**DESIGN REVIEW APPLICATION |  
REQUEST FOR RESCISSION OF DESIGN EXCEPTION**

Design Review Application **DR-23-01**  
Rescission of HRB Design Exception Request from November 14<sup>th</sup>

DESIGN REVIEW APPLICATION | DESIGN ADJUSTMENTS

Design Review Application **DR-23-01**  
Design Adjustments in Response to  
Comments from June 13<sup>th</sup>, 2023 HRB Meeting

2 SECOND FLOOR PLAN + EAST & 12th STREET ELEVATIONS

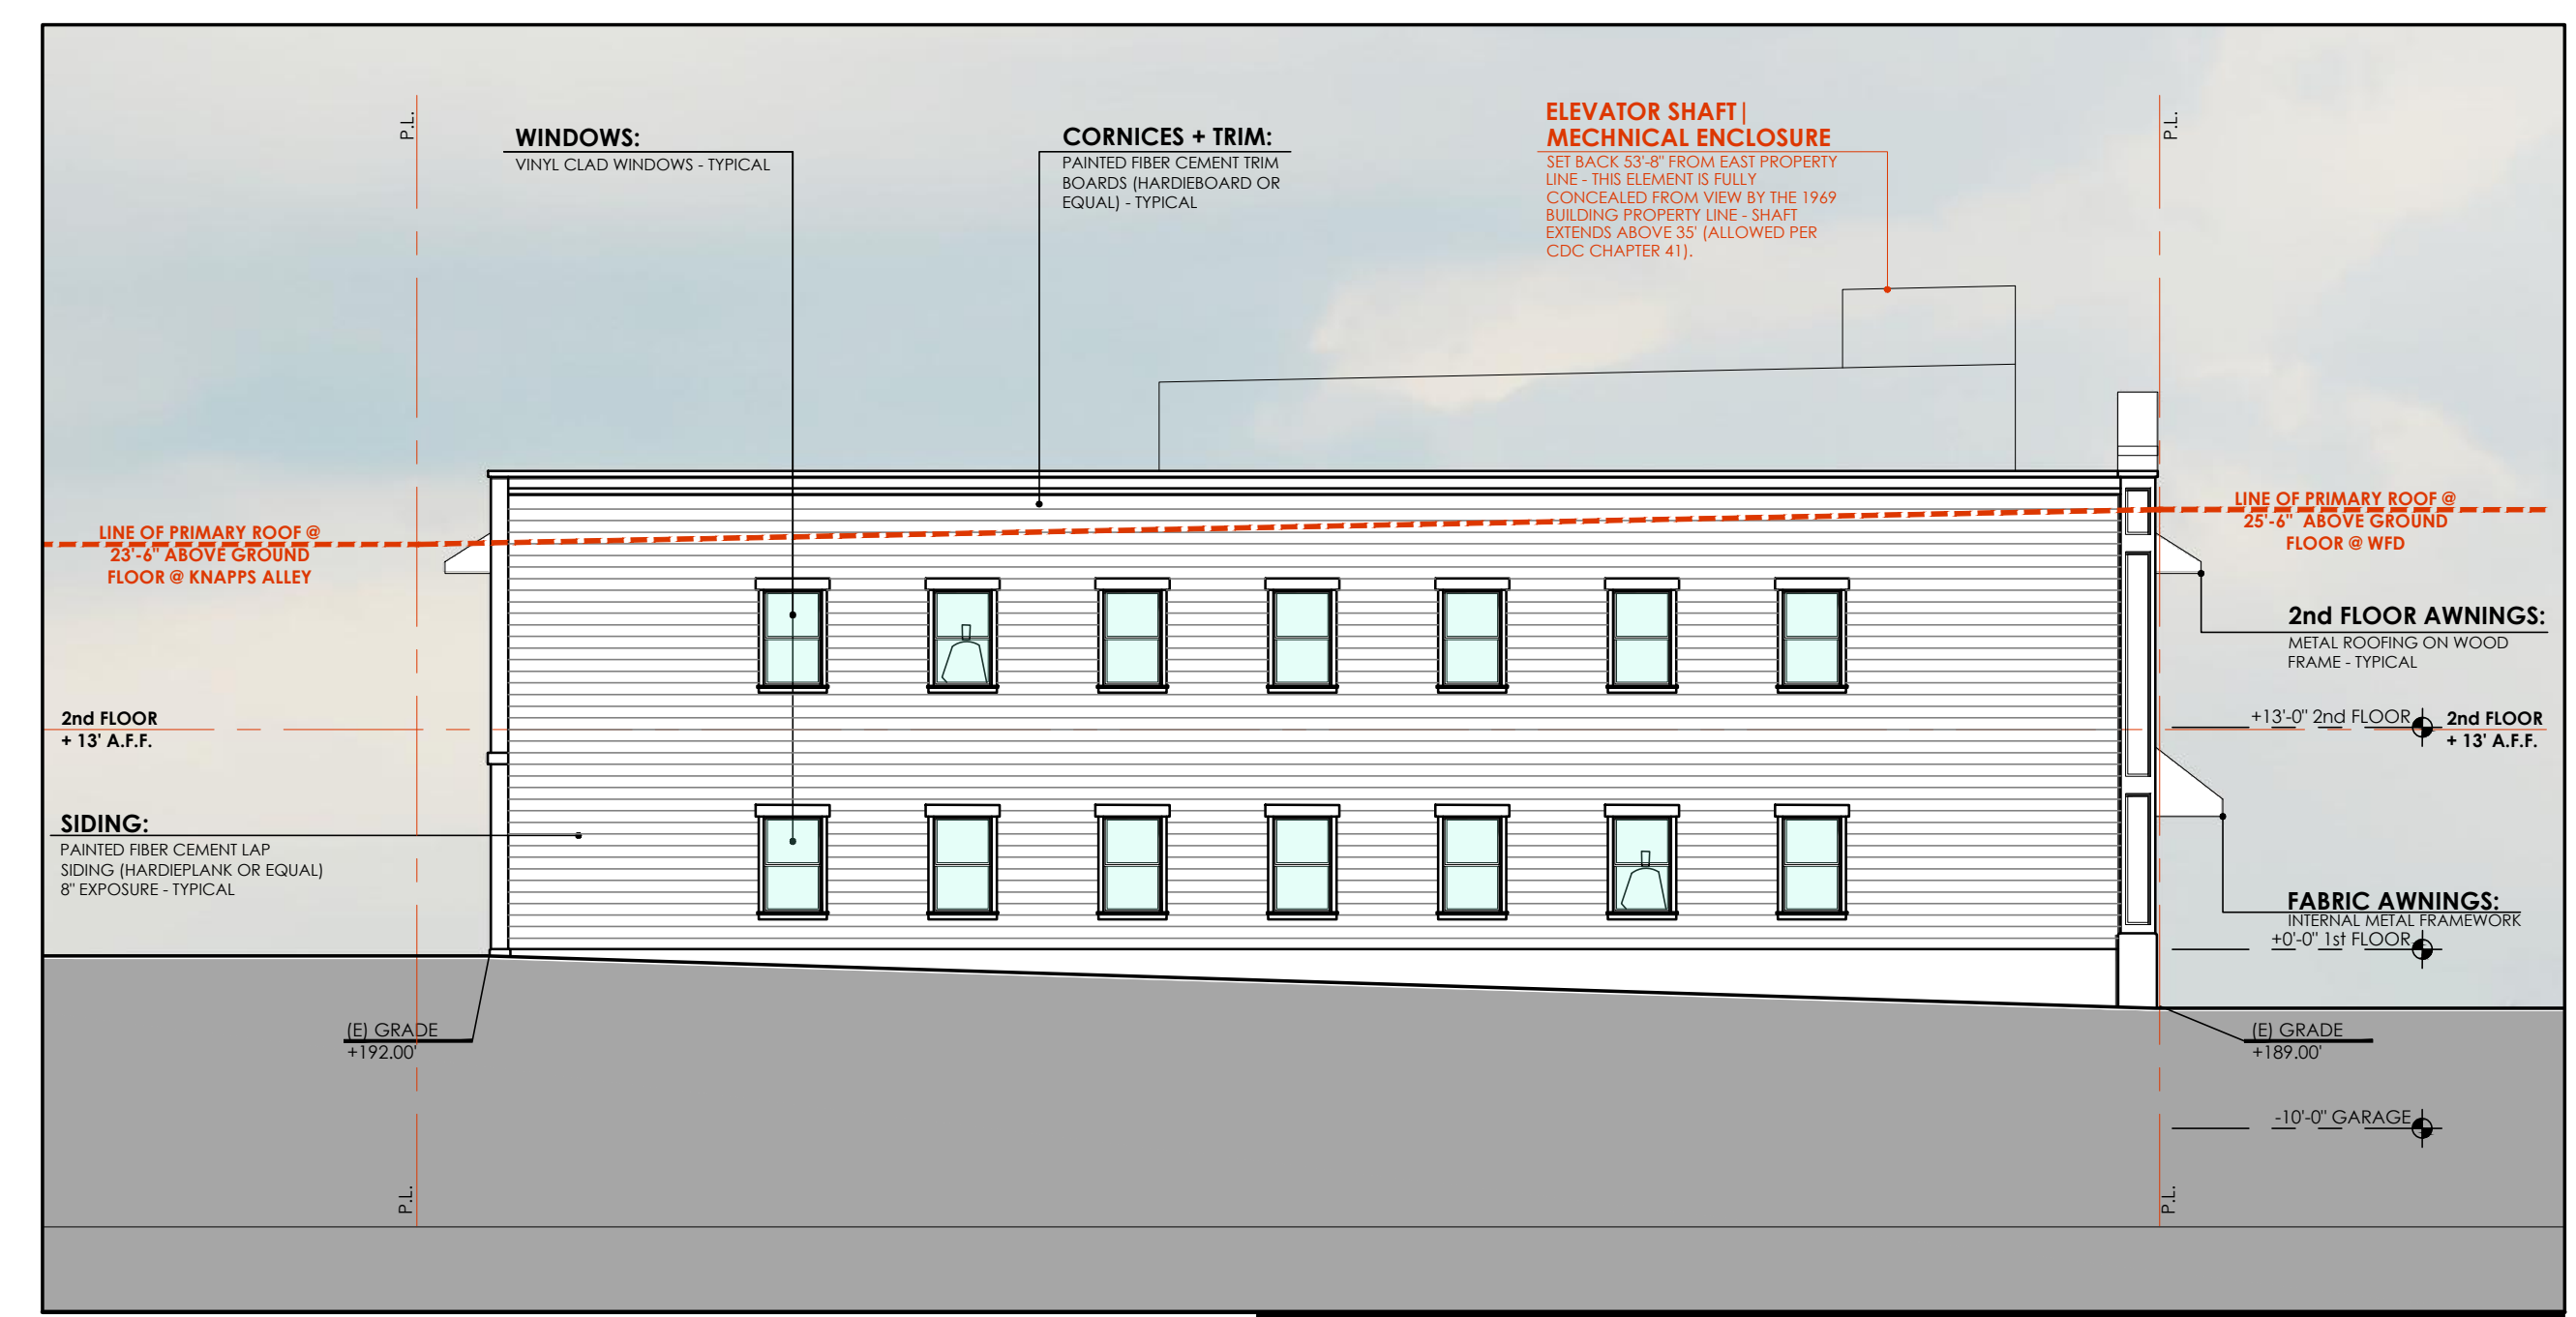
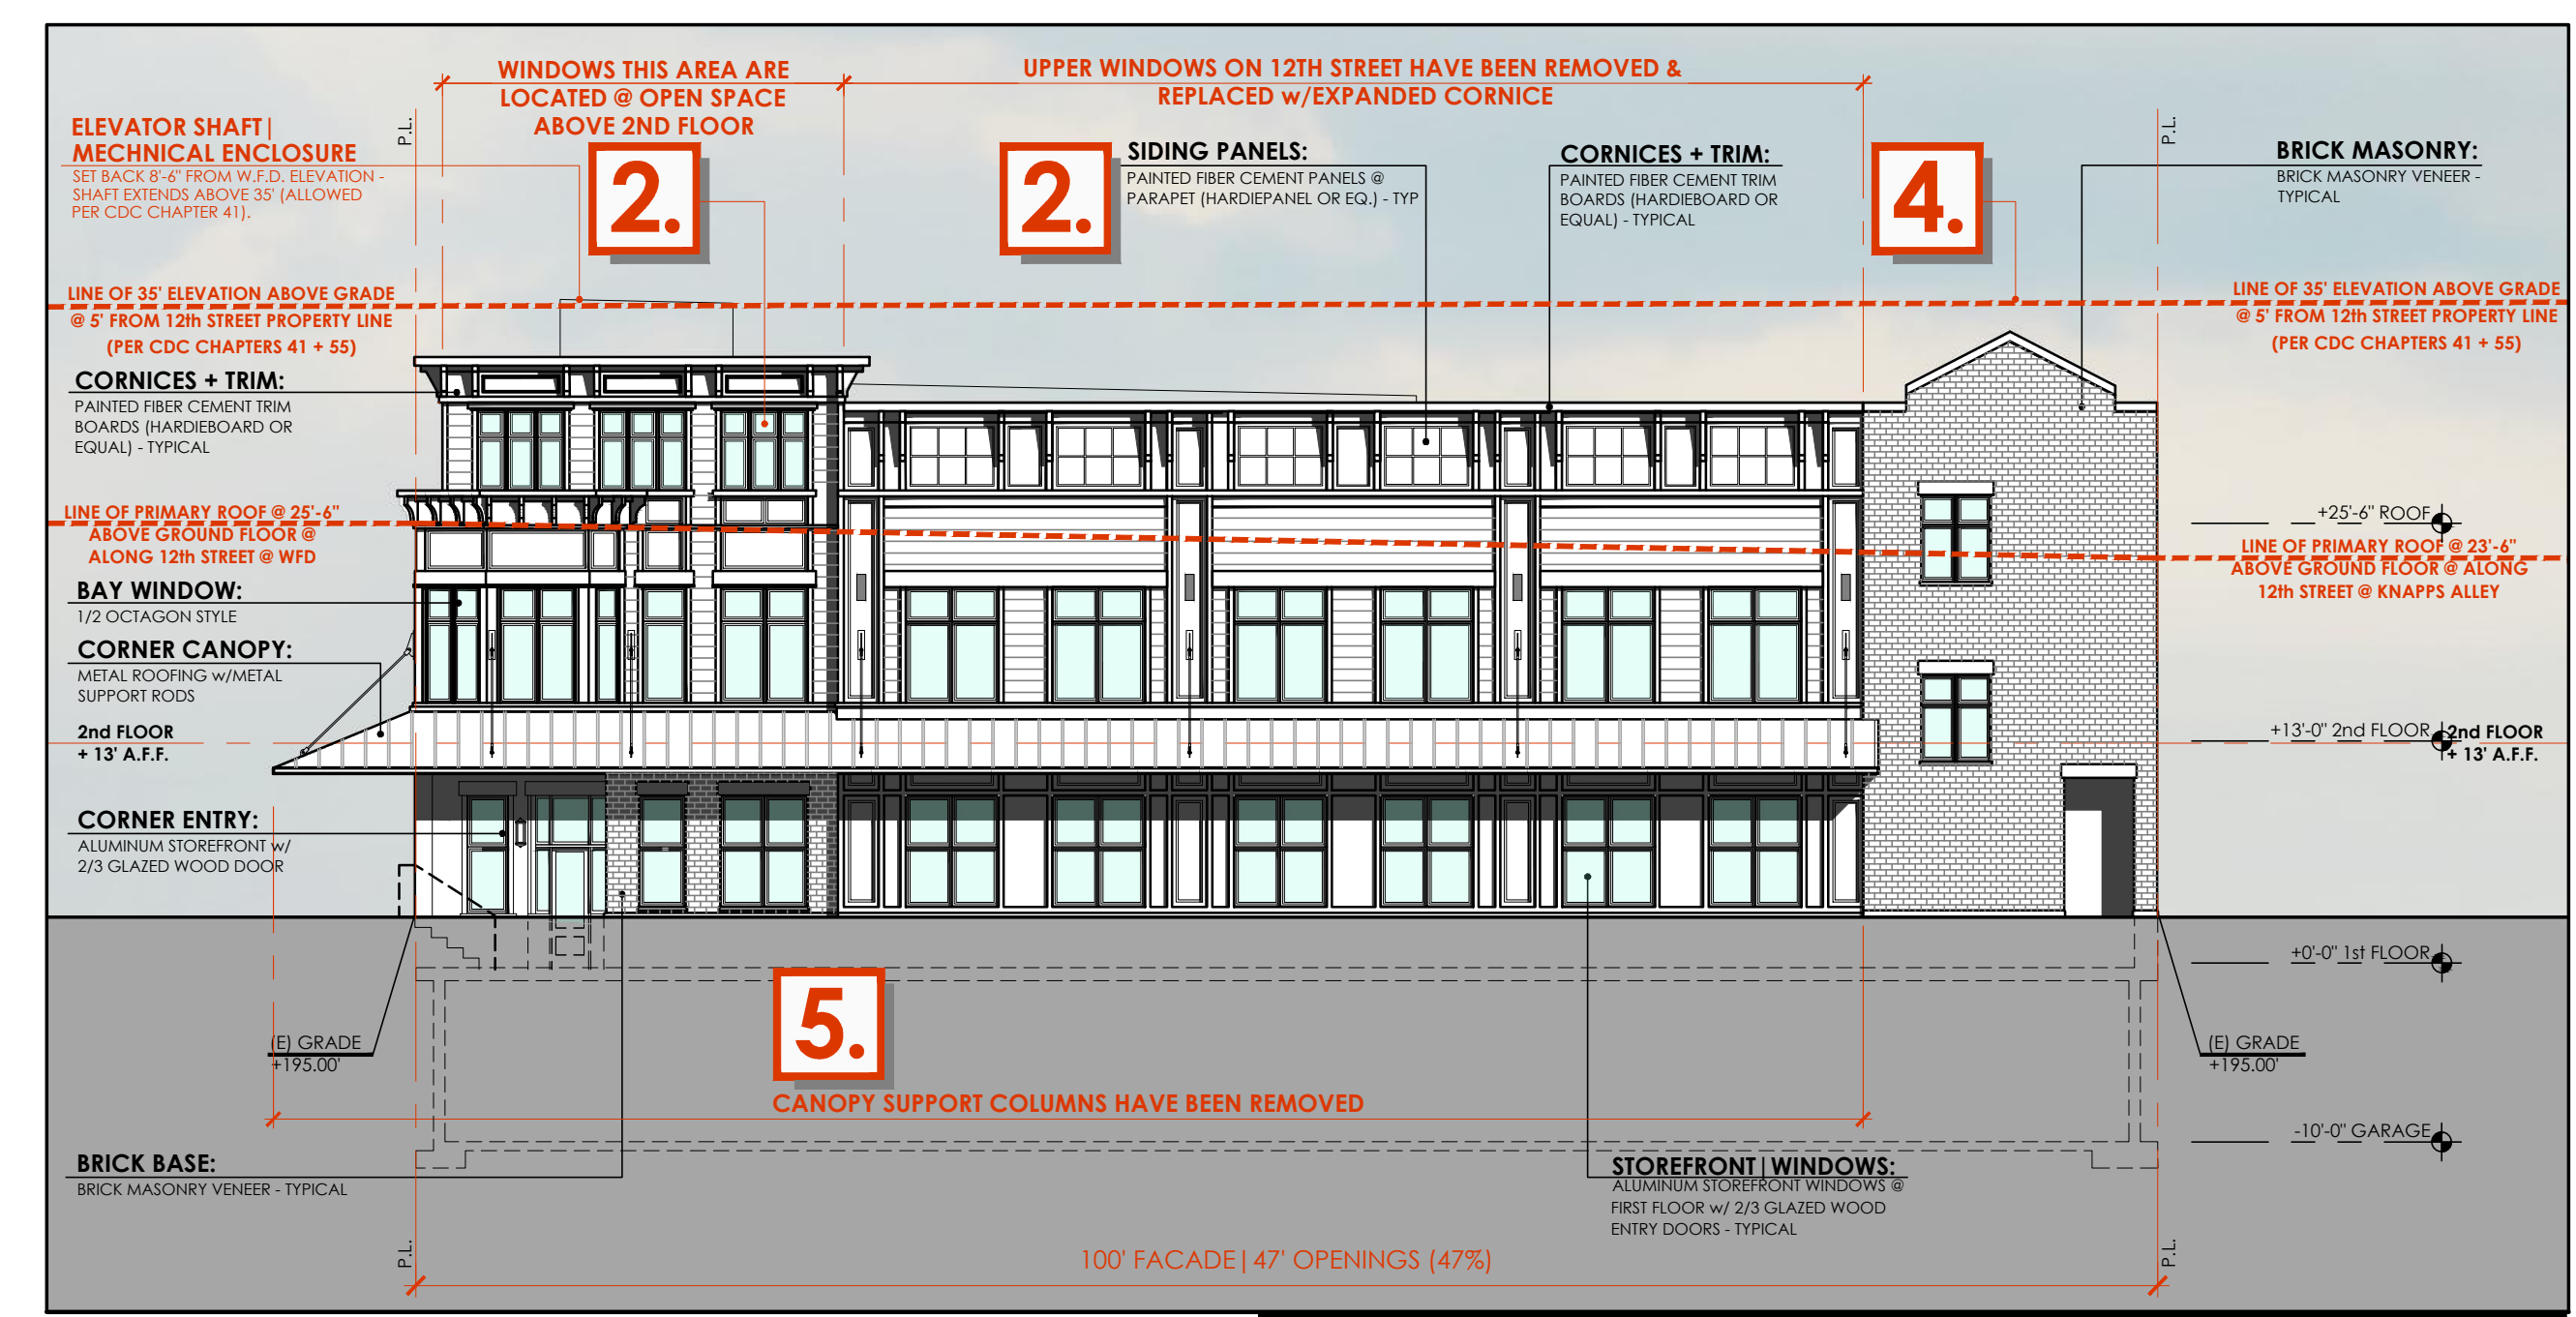
1. *CONCERN: While the IBC does not consider a mezzanine to be a separate floor, the HRB was not clear if the Willamette Falls Drive Commercial Design District Code (Chapter 58) (WFDCD) would allow for a mezzanine level above the second floor as shown in the 6/13 presentation. Further, the upper row of windows along 12<sup>th</sup> Street in the original presentation was seen by some as an indication of a 3<sup>rd</sup> floor that would not be permitted under the standards.*

- **The windows along 12th street have been removed and replaced with a redesigned cornice, painted panels, and painted vertical pilasters, breaking up the facade into vertical components. The clerestory windows remain at the corner providing additional natural light to the second floor.**
- **The enclosed rooftop lounge, restrooms, second elevator, and stair have been eliminated.**
- **A HVAC equipment space was added adjacent to the main elevator to help to mitigate noise from the units.**
- **The outdoor roof deck remains for general use by tenants and guests - with a screen surround to reduce potential noise and light issues for our residential neighbors.**

2. THE WINDOWS ALONG 12th STREET WERE REMOVED AND REPLACED WITH A REDESIGNED CORNICE, PAINTED PANELS, AND PAINTED VERTICAL PILASTERS, BREAKING UP THE FACADE INTO VERTICAL COMPONENTS. THE CLERESTORY WINDOWS REMAIN AT THE NW CORNER PROVIDING ADDITIONAL NATURAL LIGHT TO THE SECOND FLOOR.
